Water Resources Department

REQUEST FOR WRITTEN APPROVAL TO USE CONSTRUCTION METHODS NOT
INCLUDED IN OREGON ADMINISTRATIVE RULES 690-200 THROUGH 690-210

(1) Location of Well: NW 1/4 SW 1/4 of Section 34, Township 2 South,
Range 7 East, Clackamas County.

(2) Start Card Number(s): 115778

- (7) Diagram showing the pertinent features of the proposed well design and construction (attach additional pages if needed):

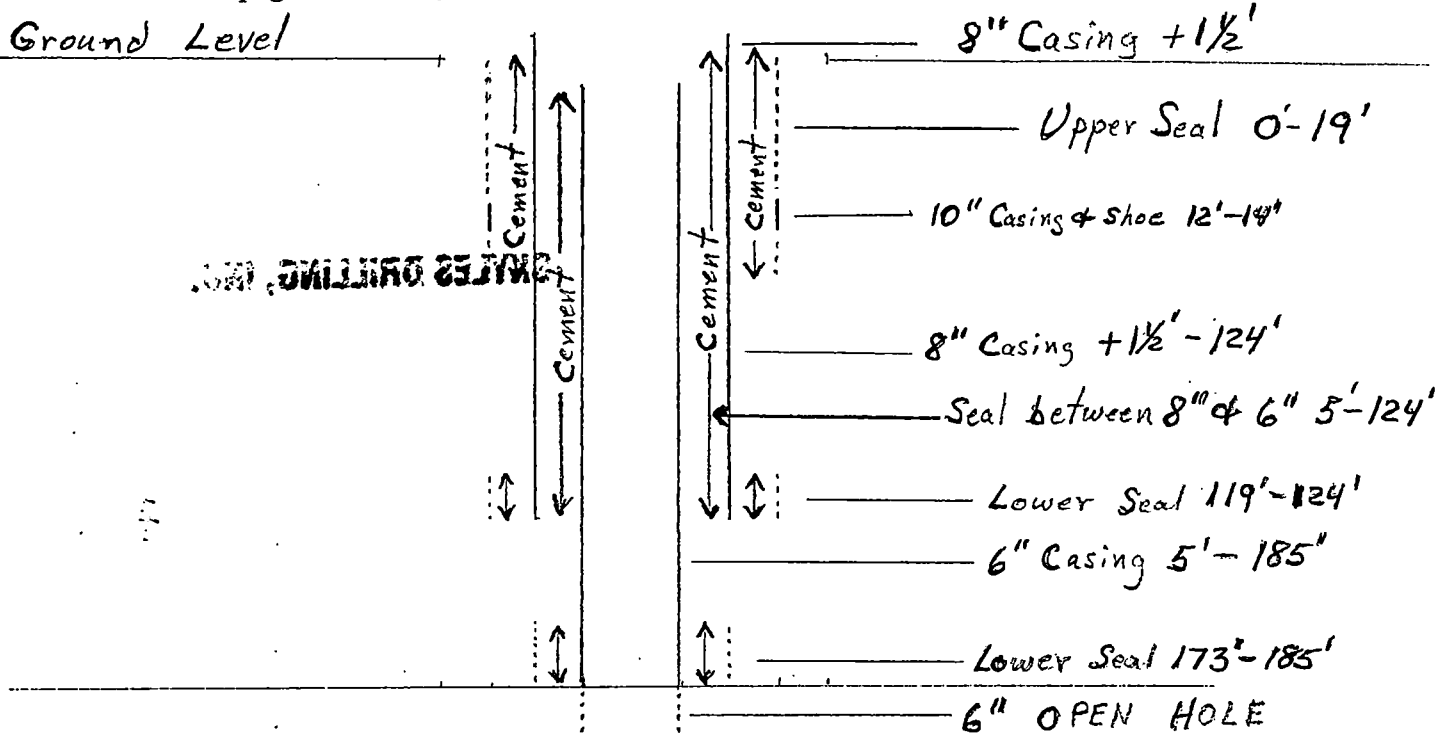
(5) The unusual conditions which necessitate this request: 10 INCH CASING
WON'T JACK OUT ALL THE WAY.

DIG Minimum 10 feet (Deeper if possible)
Cut off 10 inch casing and remove after
pumping in upper seal. Leaving balance of 10
inch with the drive shoe in the hole.

50gpm Flowing Artesian
Artesian Pressure 20 lbs.

Date: 11.30.98

Approved by: Michael J. McLeod Denied by: _____
